# UNITED STATES PATENT AND TRADEMARK OFFICE

<b>Office Action Summary</b>	<b>Application No.</b> 10/582,405	<b>Applicant(s)</b> TANAKA, TADAHISA	
	<b>Examiner</b> HENRY LIU	<b>Art Unit</b> 3657

This is the first action on the merits for application 10/582405. **Claims 1 and 2** are pending, of which **Claims 1 and 2** are in independent form.

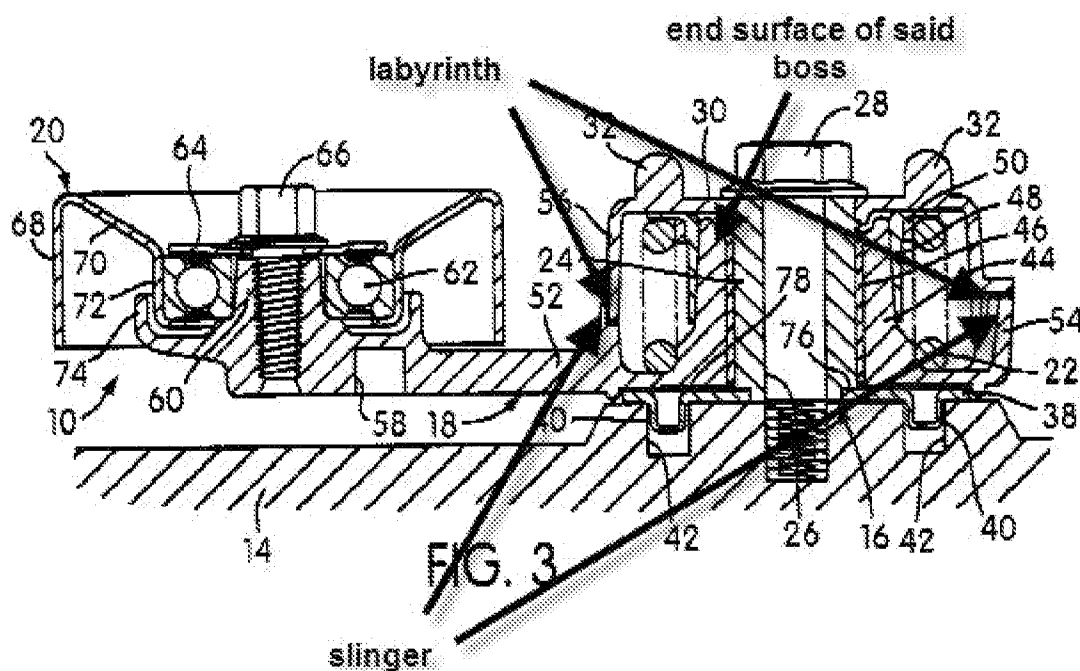
BELLAMY teaches a boss (44) being formed with a shaft inserting hole, a tubular fulcrum shaft (24) mounted in said shaft inserting hole, a bolt (28) axially extending through said fulcrum shaft (24) and configured to be brought into threaded engagement with an engine block (Col. 2 lines 40-55) and tightened to fix said fulcrum shaft (24) to the engine pulley (20), thereby pivotally supporting said pulley arm (18) (Fig. 3).

BELLAMY teaches a washer (30) (Fig. 3) disposed between a head of said bolt (28) and an end surface of said boss (44), said washer having a cylindrical portion (56) (Fig. 3) covering an end portion of said boss (44) including said end surface, and that a slinger is mounted on said end portion of said boss (44), said cylindrical portion (56) of said washer (30) and said slinger defining a labyrinth therebetween." See figure below.

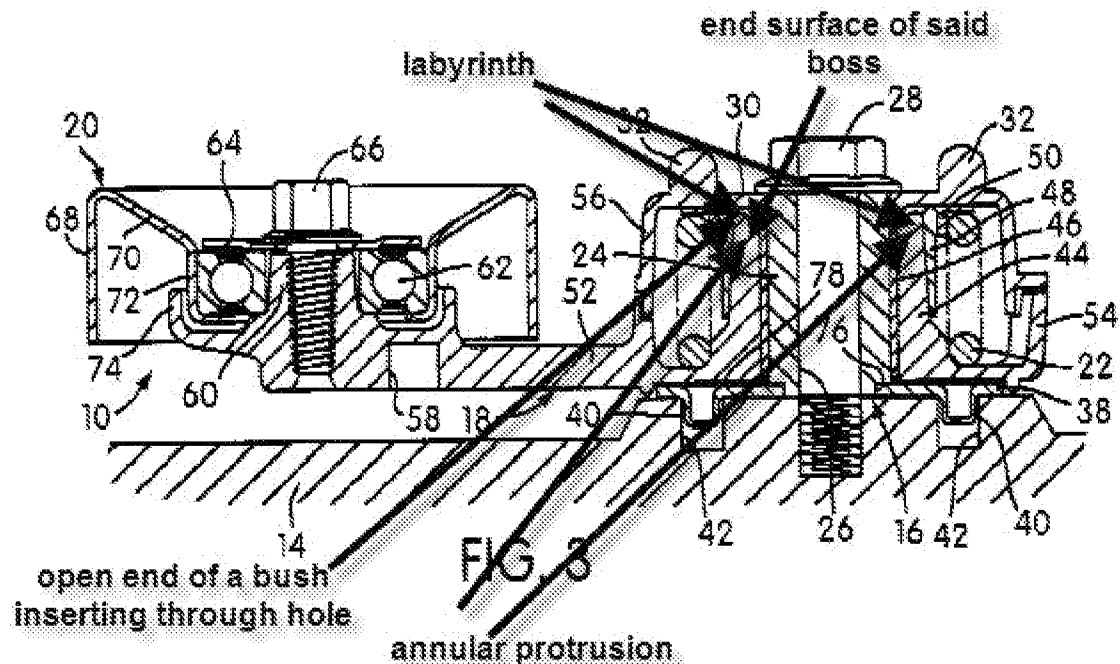
Regarding Claim 2, KATOGLI teaches “A tension adjusting device (Fig. 1) for an engine accessory driving belt (7) comprising a tension pulley (5) configured to be brought into contact with the engine accessory driving belt (7), a pivotable pulley arm (1) supporting said tension pulley (5), a hydraulic auto-tensioner (6) for applying a regulating force to said pulley arm (1), thereby pressing said tension pulley (5) against the belt (7), said auto-tensioner (6) having at one end thereof a coupling piece (28) formed with a bush inserting through hole (29) extending between two sides thereof (Fig. 2) a tubular bush (30) inserted in said bush inserting through hole (29) and a bolt (31) inserted through said bush (30).” KATOGLI teaches a bolt (31) in threaded engagement with an engine block (3).

KATOGLI does not teach “brought into threaded engagement with said pulley arm and tightened to fix said bush to said pulley arm, thereby pivotally coupling said one end of said hydraulic auto-tensioner to said pulley arm.”

KATOGLI does not teach "characterized in that two washers are disposed between opposed surfaces of said bush and said pulley arm and between opposed surfaces of said bush and a head of said bolt, respectively, each of said washers having an outer cylindrical portion extending toward said coupling piece, and that said coupling piece has two annular protrusions each formed at one of two open ends of said bush inserting through hole, said cylindrical portion of each of said washers and the corresponding one of said annular protrusions defining a labyrinth therebetween."

BELLAMY teaches a washer (30) disposed between opposed surfaces of said bush (24) and a mounting surface (12) (Fig. 1) and between opposed surfaces of said bush (24) and a head of said bolt (28) (Fig. 3). The washer has a cylindrical portion (56) extending toward a coupling piece (18), which has an annular protrusion at an open end of a bush inserting through hole, said cylindrical portion (56) of the washer and annular protrusions defining a labyrinth therebetween." See figure below.
